The Commission has issued the enclosed Amendment No. 67 to Facility Operating License No. NPF-5, for the Edwin I. Hatch Nuclear Plant, Unit No. 2. The amendment consists of changes to the Technical Specifications in response to your application dated July 18, 1986.

The amendment (1) revises allowable values to provide for the use of Rosemount, as well as Barton, transmitters for certain instrumentation channels associated with the Analog Transmitter Trip System (ATTS); (2) provides administrative clarifications; (3) revises allowable values for instruments which actuate on high drywell pressure; and (4) lowers the core spray and residual heat removal low pressure coolant injection low reactor pressure injection permissive setpoints to allow for increased flexibility in the use of Rosemount transmitters for this trip function.

AMENDMENT TO FACILITY OPERATING LICENSE

Amendment No. 67
License No. NPF-5

BASES FIGURE B 3/4 3-1
REACTOR VESSEL WATER LEVELS

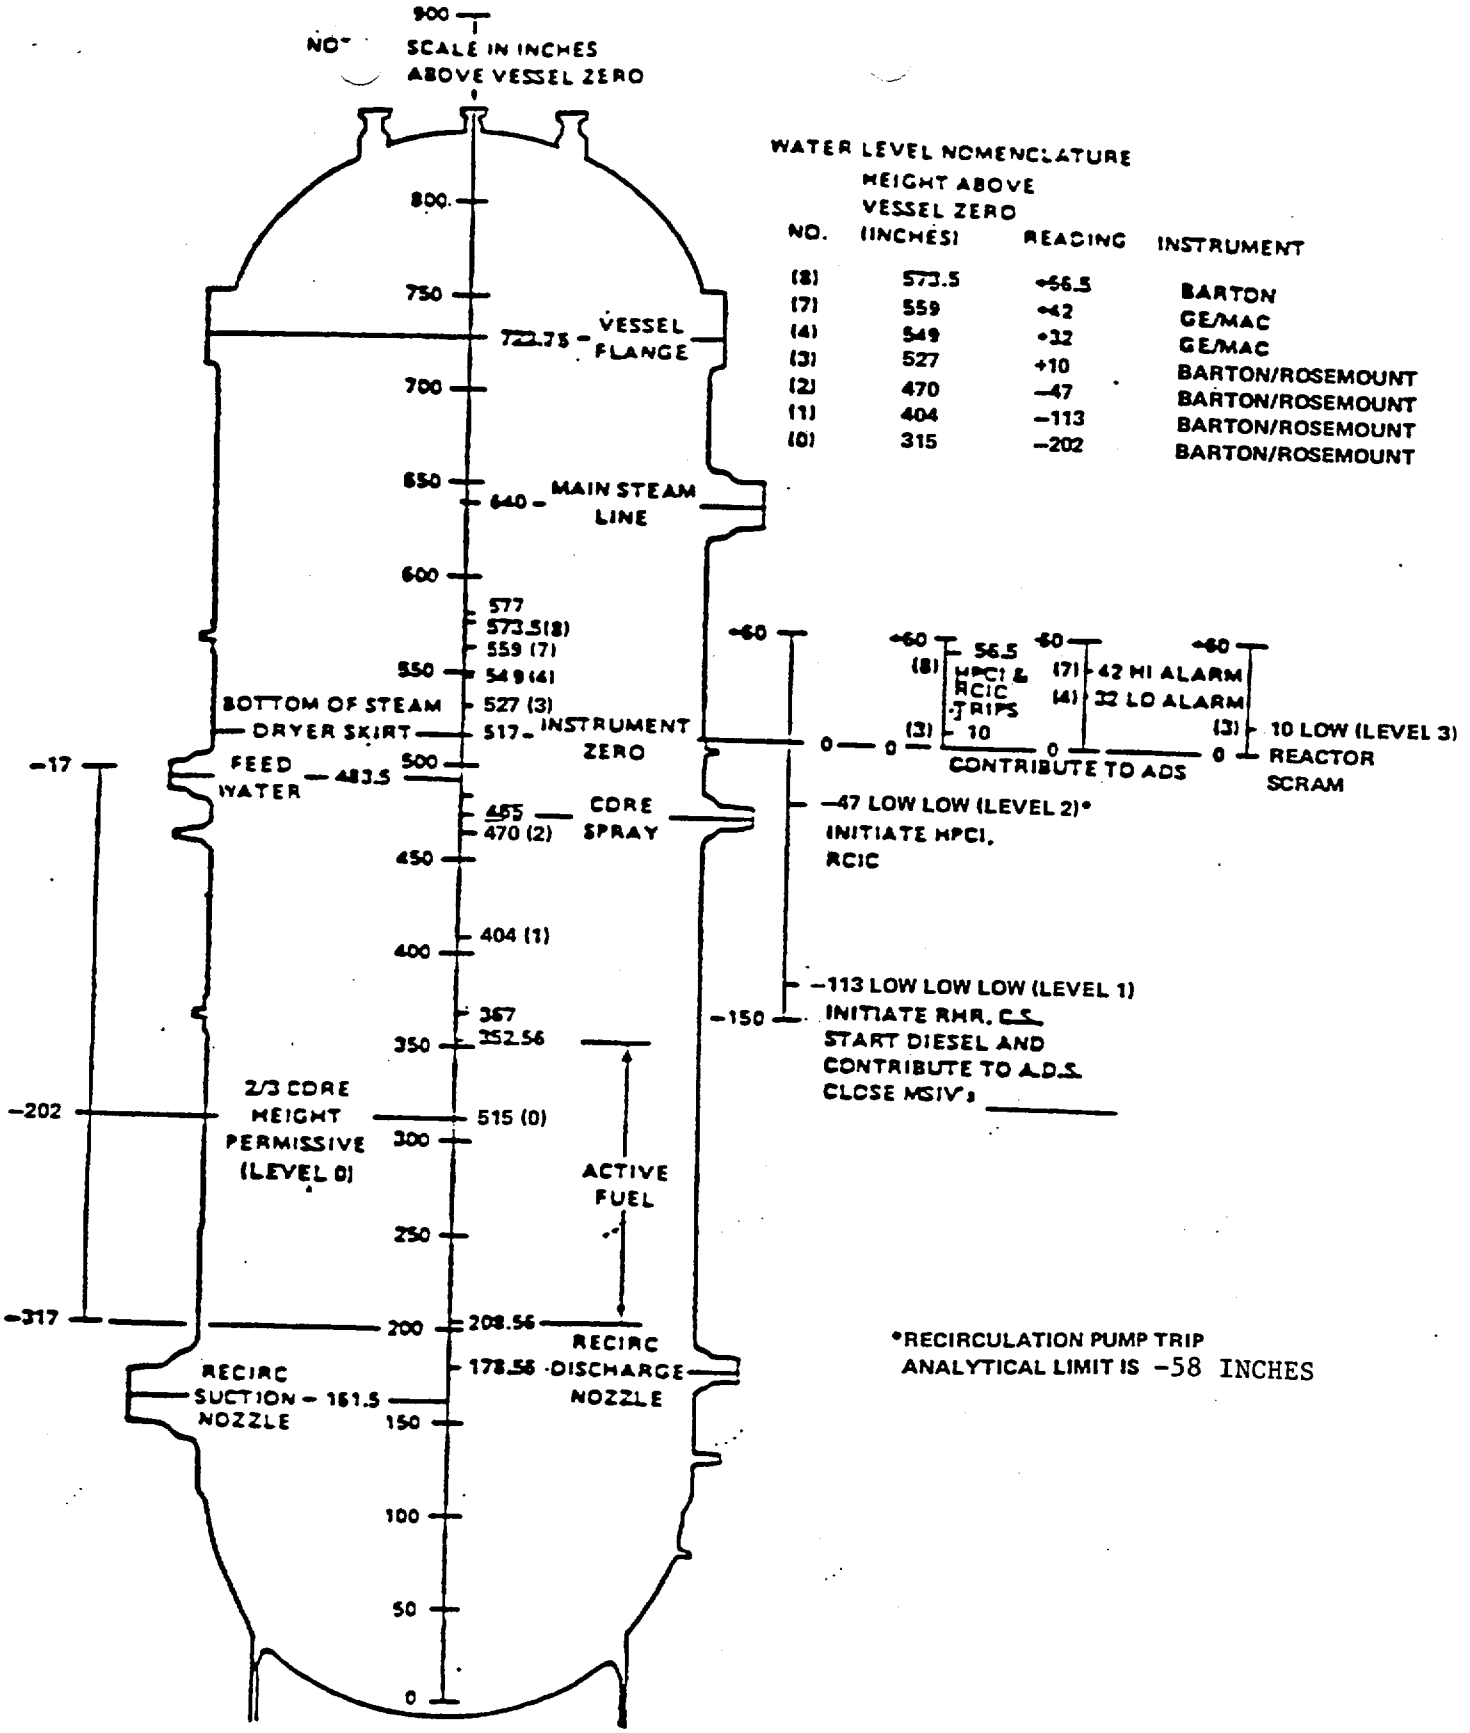
Trip Function	Present Allowable Value	Proposed Allowable Value
Reactor Vessel Water Level 1	-121.5 inches	-113 inches
Reactor Vessel Water Level 2	-55 inches	-47 inches
Reactor Vessel Water Level 3	8.5 inches	10 inches
Reactor Shroud Water Level 0	-207 inches	-202 inches
Reactor Vessel Steam Dome Pressure Low	325 psig	335 psig
HPCI Steam Line High Flow	307%	303%
RCIC Steam Line High Flow	307%	312%
